Fishermans Bend Planning Review Panel Reports

Fishermans Bend Planning Review Panel

Report No. 1 – Volume 1

19 July 2018

Figure 7: Degree of fit between FAR and height limits

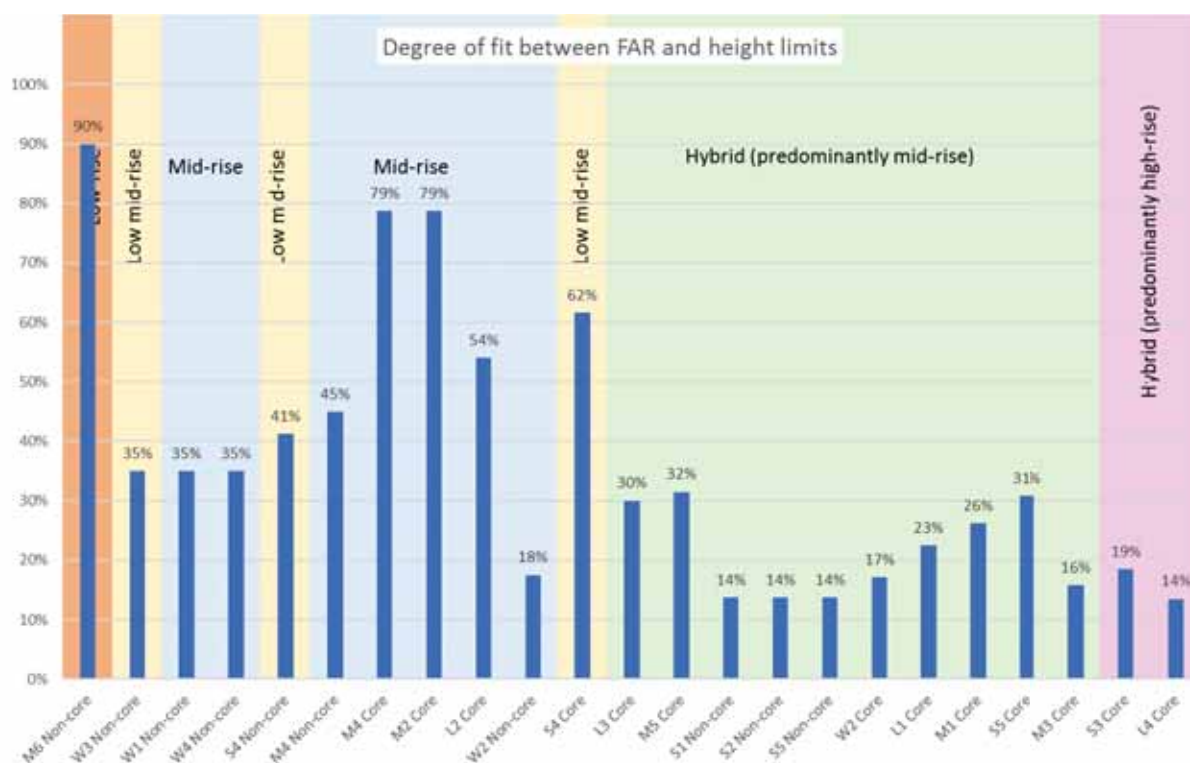
Figure 7 is the Review Panel version of Figure 9 from SIN 21. It shows the height permitted under the FAR for a building that covers 100 per cent of a site, as a percentage of the tallest maximum height in the subprecinct.

While it is true that the subprecincts with the tallest maximum heights have the loosest fit, there is a great deal of variation between subprecincts with the same typology. Within the mid-rise typology, the looseness of fit ranges from 18 per cent for Subprecinct W2 in Wirraway, to 79 per cent for Montague M2 and M4.

Figure 15: The tooth and gap approach

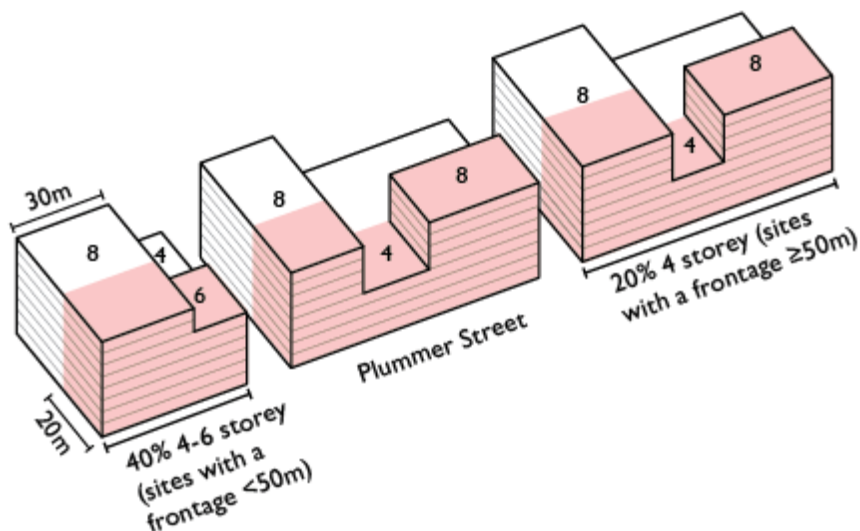
The Review Panel agrees that there is merit in this approach in some locations, which is illustrated in Figure 15.

Figure 4: Lorimer subprecinct map

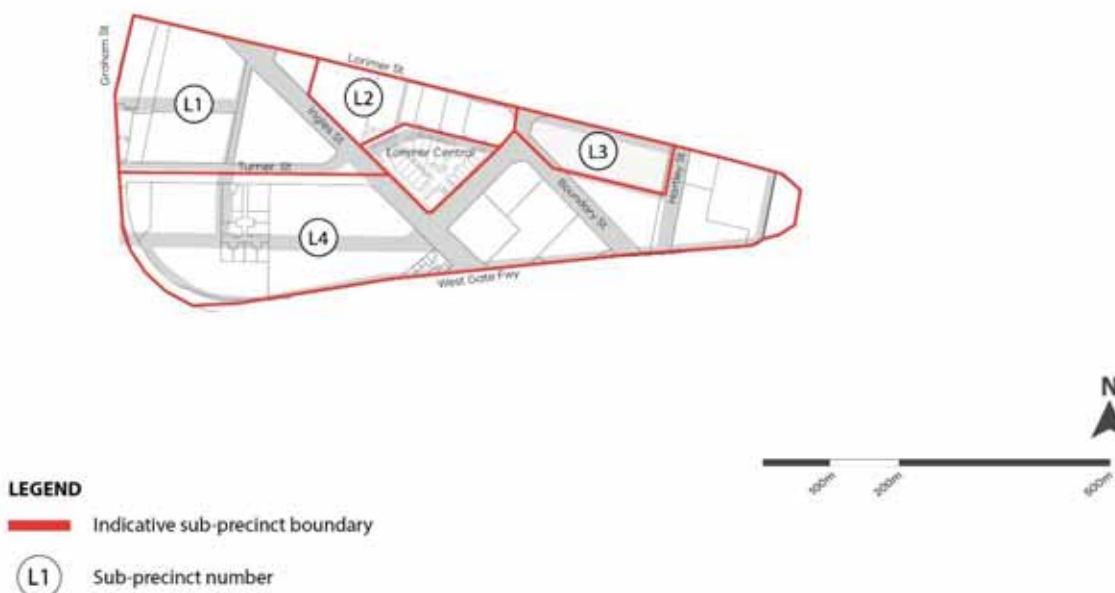
Subprecinct boundaries as proposed by the Minister are set out in Figure 4. The Minister indicated that there is an error in the location of the boundary between subprecincts L1 and L2 north of Ingles Street, which needs to be corrected to accord with the boundary of the 24 storey height limit, as shown in D342. The Review Panel supports this change.

Figure 9: Alternative access under the Ingles Street overpass, GTA Consultants

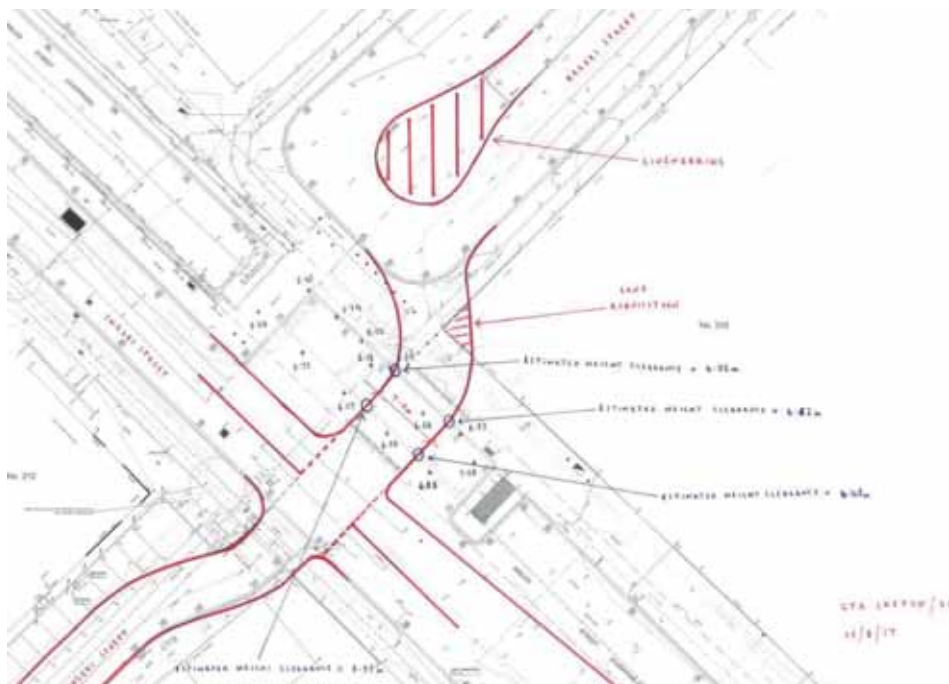
Site access to Ingles Street and to the broader Precinct is problematic in that the existing Ingles Street overpass is low and restricts access to Rogers Street for larger vehicles. GTA Consultants prepared a concept sketch where enhanced access could be readily achieved by shifting the proposed new collector road to the south of the site (where approximately four metres of vertical clearance under the overpass would be available). However this solution requires a small corner of the Barro property to be acquired (refer to Figure 9).

Dexus believed that flexibility is required in relation to the location of the proposed collector road, or alternatively that the proposed road alignment should be reconsidered, particularly if the Ingles Street Bridge (which is to be reconstructed to provide Disability Discrimination Act compliant footpaths, and to increase the vertical clearance under the bridge) is not planned to occur for some time.

Figure 4: Tooth and gap typology, with preferred heights

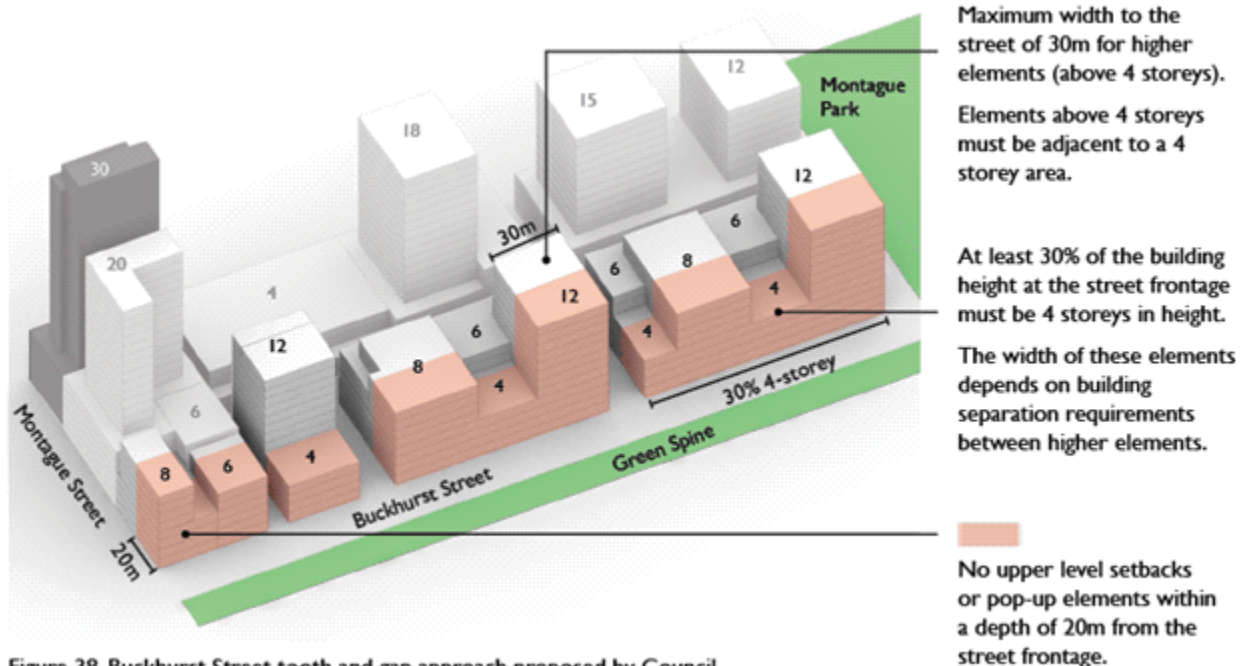
Port Phillip submitted that in the Montague retail core, *“Consideration be given to a different approach to the traditional street wall and tower setback approach for Buckhurst Street between Montague Street and Ferrars Street to create a diversity of heights at the street interface and maximise sunlight penetration.”* It argued that the heights should be lowered from 20 to 12 storeys on the north side of Buckhurst Street and to apply the ‘tooth and gap’ building typology. Figure 4 shows the tooth and gap typology and preferred heights sought by Port Phillip.

Figure 9: New road suggested by Port Phillip

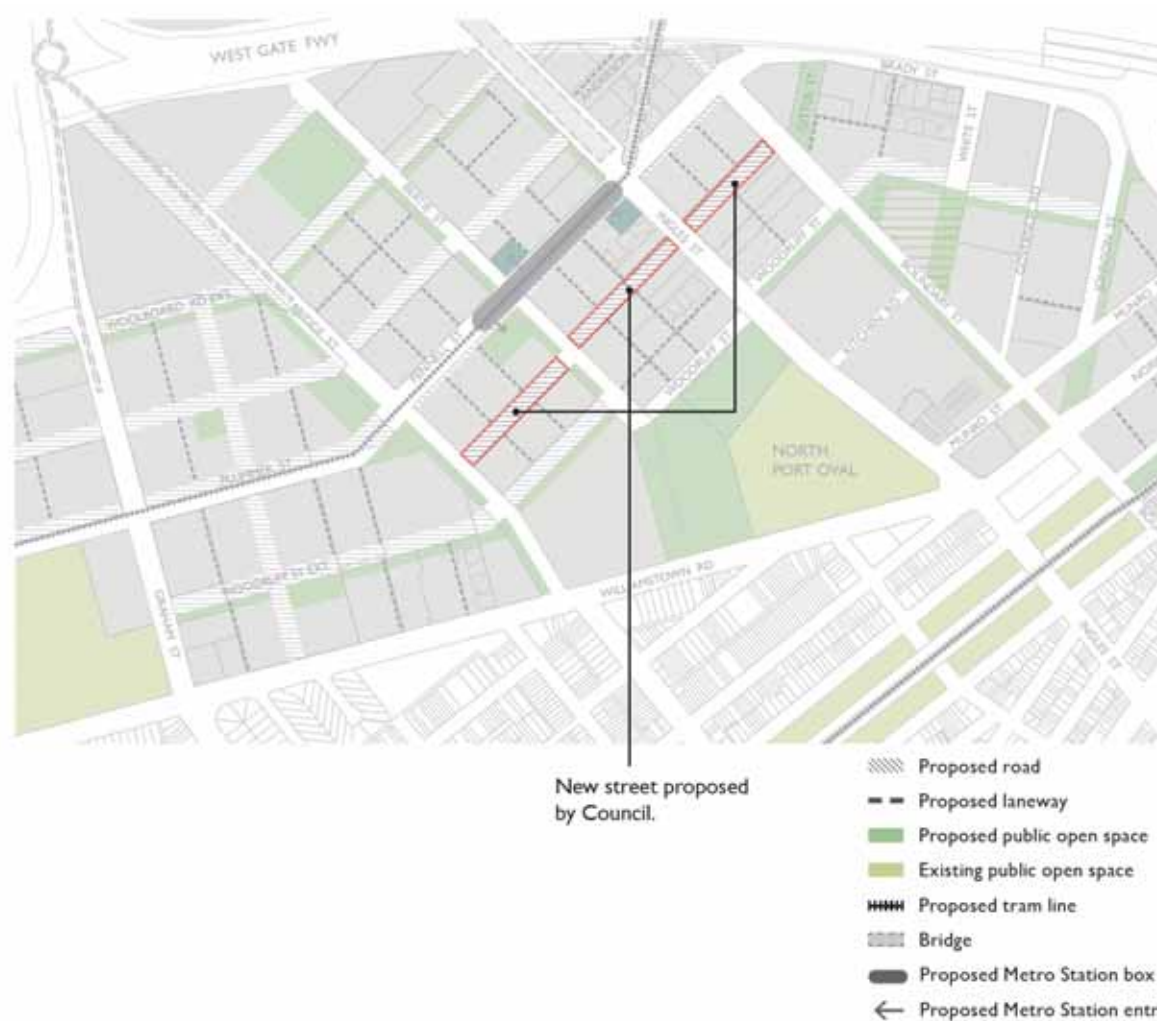
Port Phillip submitted that the draft Amendment should be changed to include an additional 22 metre wide road in the Sandridge core, as shown in Figure 9. This was based on its analysis that the block size was too large in this area.

Figure 6: Wirraway core and subprecinct boundaries

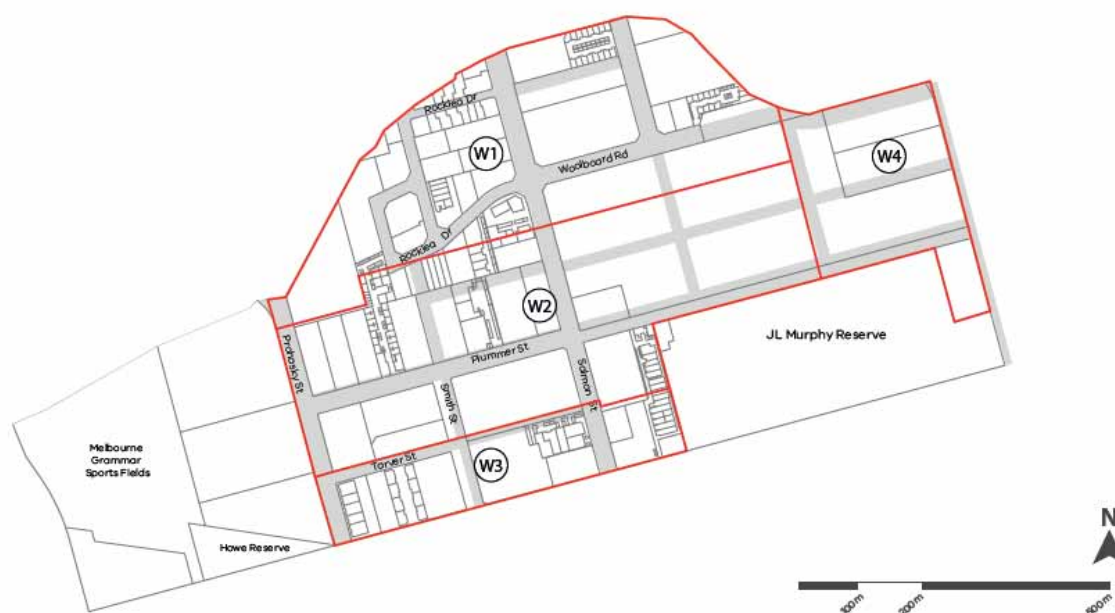
Core and subprecinct boundaries as proposed by the Minister are set out in Figure 6.

Port Phillip submitted that the boundary of subprecinct W2 be moved to align with the core area of Wirraway.

Figure 9: Location of proposed east-west road

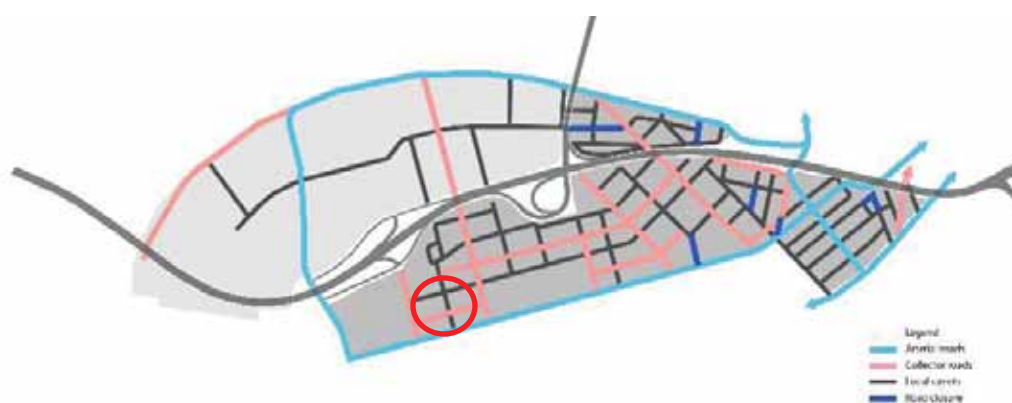
When considering the broader aspects, in particular urban realm, permeability, and street activation, the Review Panel considers that on balance the proposed east west road should be retained. The Review Panel notes that this is shown as a collector road in the Framework Figure 6 Proposed Road Hierarchy, circled in Figure 8, and as such is an important part of the road network.
